Access Compliance Report

Public Rights-of-Way

(Curb Ramps)

Intersection ID: 5162	Main Street: BROOKFIELD_POINTE_DR	Cross Street: SUNSET_RD	Location:	W
ADA ID: A9021CFF1FF5	Ramp Type: Perp	Initial Pass/Fail: Fail	Overall Compliance: No	Severity Score: 22.5
Codes/Mitigation Info/Possible Solution		Field Measurements/Component Compliance

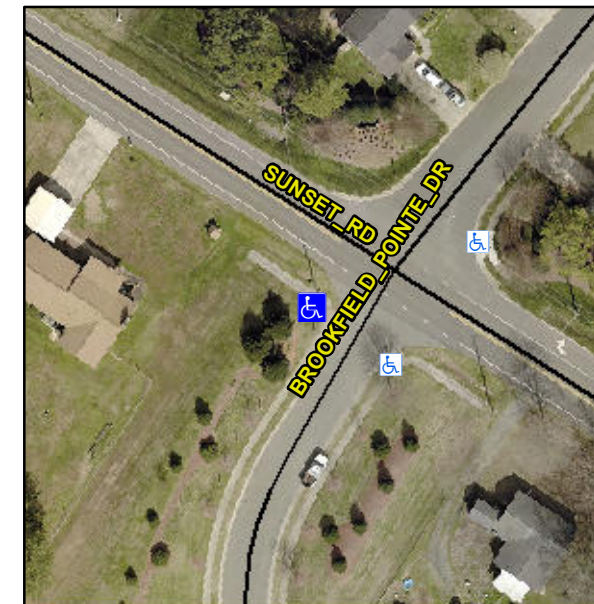
Not Found, R304.5.1, R304.2.2, R304.5.3

Compliance	Description	Data	Compliance	Description	Data
N/A	Ramp Length (in)	48.0	No	Ramp Slope (%)	8.8
No	Ramp Width (in)	41.5	No	Ramp XSlope (%)	2.4
N/A	Flare Type LT	N/A	N/A	Flare Type RT	N/A
N/A	Flare Slope LT (%)	N/A	N/A	Flare Slope RT (%)	N/A
N/A	Flare Traversable LT?	N/A	N/A	Flare Traversable RT?	N/A
N/A	Landing Length (in)	N/A	N/A	DWS Provided?	N/A
N/A	Landing Width (in)	N/A	N/A	DWS Contrast?	N/A
N/A	Landing Slope (%)	N/A	N/A	DWS Length (in)	N/A
N/A	Landing X Slope (%)	N/A	N/A	DWS Full Width?	N/A
N/A	Landing Curb? (Y/N)	N/A	N/A	DWS Offset (in)	N/A
N/A	Shared Landing?	N/A			
N/A	Gutter Ponding?	N/A	N/A	Gutter Slope (%)	N/A
N/A	Gutter Lip Ht (in)	N/A	N/A	Gutter X Slope (%)	N/A
N/A	Painted X Walk1?	No	N/A	Painted X Walk2?	N/A
	X Walk 1 Direction	To SE		X Walk 2 Direction	N/A
N/A	X Walk 1 Width (in)	N/A	N/A	X Walk 2 Width (in)	N/A
	X Walk 1 Slope (%)	2.5		X Walk 2 Slope (%)	N/A
	X Walk 1 X Slope (%)	4.2		X Walk 2 X Slope (%)	N/A

Remove & Replace Entire Ramp.
